STAFF REPORT

SUBJECT: H-2021-0073
Inglewood Coffee Shop Drive-Through – CUP

LOCATION: 3330 E. Victory Rd., in the SW ¼ of Section 21, Township 3N., Range 1E.

PROPERTY NO. LANDSCAPE PLANTING PLAN

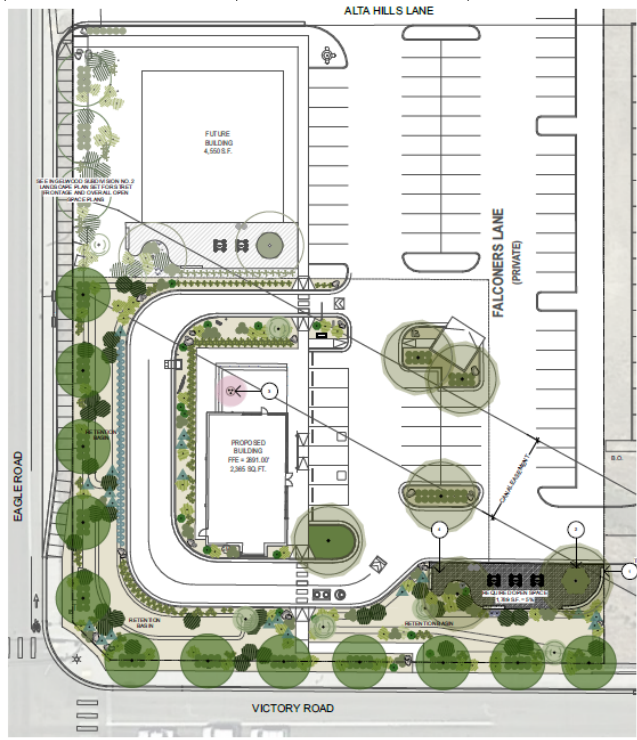
Landscaping: Parking lot landscaping is required to be provided in accord with the standards listed in UDC 11-3B-8C; where it's not feasible to comply with the standards due to the irrigation district easement for the McDonald Lateral, alternative compliance should be requested as set forth in UDC 11-5B-5. **The landscape plan submitted with the Certificate of Zoning Compliance application should reflect compliance with this standard; or an alternative compliance application should be submitted.**

Street buffer landscaping along S. Eagle Rd. and E. Victory Rd. is required to be installed with the Phase 2 subdivision improvements. **Because ACHD is requiring the construction of a northbound right-turn lane on Eagle Rd. that may affect the width of the street buffer approved with the**

final plat, Staff recommends the site and landscape plans are updated accordingly to include the right-turn lane and the minimum 25-foot wide street buffer along Eagle Rd. required by UDC Table 11-2B-3. If the existing sidewalk is being removed to allow for the construction of the right-turn lane, a detached sidewalk should be constructed in accord with UDC 11-3A-17C.

- e. Depict landscaping within all planter islands within the parking area in accord with the standards listed in UDC [11-3B-8C](#); where it's not feasible to comply with the standards due to the irrigation district easement for the McDonald Lateral, alternative compliance shall be requested as set forth in UDC [11-5B-5](#).

- f. Depict the northbound right-turn lane on S. Eagle Rd. as required by ACHD with a minimum 25-foot wide street buffer in accord with UDC Table 11-2B-3 and a 5-foot wide detached sidewalk in accord with UDC 11-3A-17C.

C. Building Elevations (dated: 7/21/21)

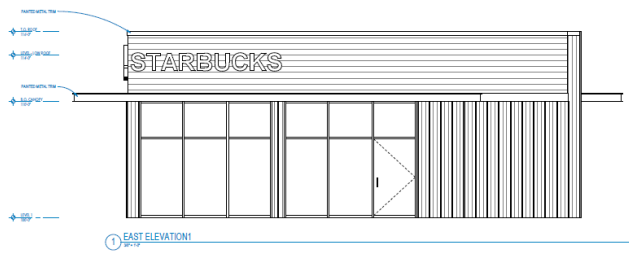
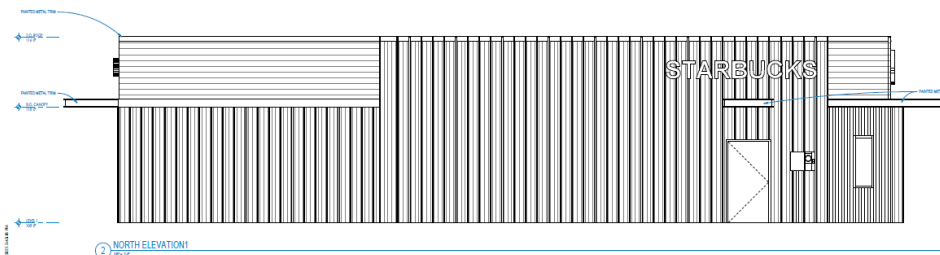
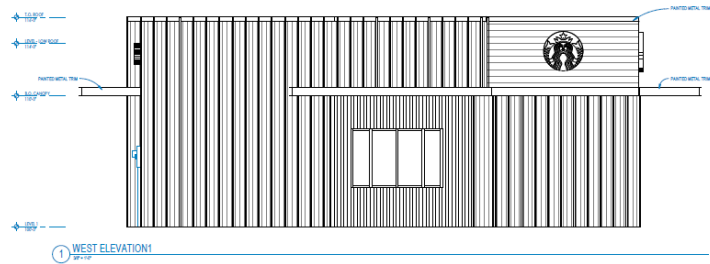
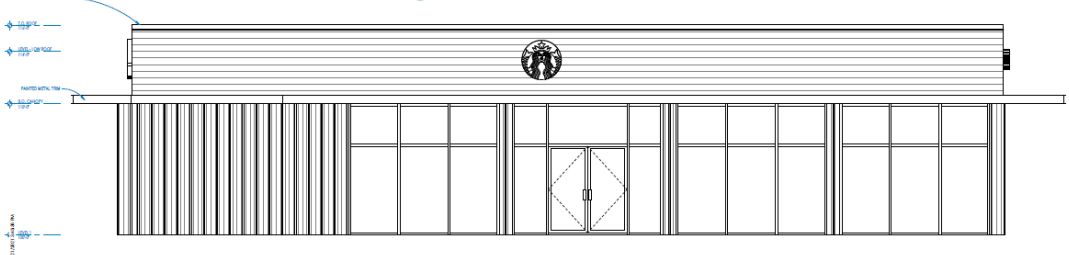
Mechanical Equipment: All mechanical equipment on the back of the building and outdoor service and equipment should be incorporated into the overall design of buildings and landscaping so that the visual and acoustic impacts of these functions are fully contained and out of view from adjacent properties and public streets as set forth in UDC [11-3A-12](#).

Building Elevations: Conceptual building elevations were submitted as shown in Section VII.C that incorporate a mix of materials consisting of fiber cement lap and board and batten siding with metal panel accents. The proposed materials are consistent with those in the residential portion of the development to the east in accord with the Development Agreement. The final design shall be consistent with the design standards listed in the [Architectural Standards Manual](#) and with the Development Agreement.

- b. All mechanical equipment on the back of the building and outdoor service and equipment areas should be incorporated into the overall design of buildings and landscaping so that the visual and acoustic impacts of these functions are fully contained and out of view from adjacent properties and public streets as set forth in UDC [11-3A-12](#).

7. A Certificate of Zoning Compliance and Design Review application shall be submitted and approved for the proposed use prior to submittal of a building permit application. The design of the site and structure shall comply with the standards listed in UDC [11-3A-19](#); the design standards listed in the *Architectural Standards Manual* and with the Development Agreement. *The Development Agreement requires some of the same design elements to be incorporated in the commercial portion of the development as in the residential portion.*
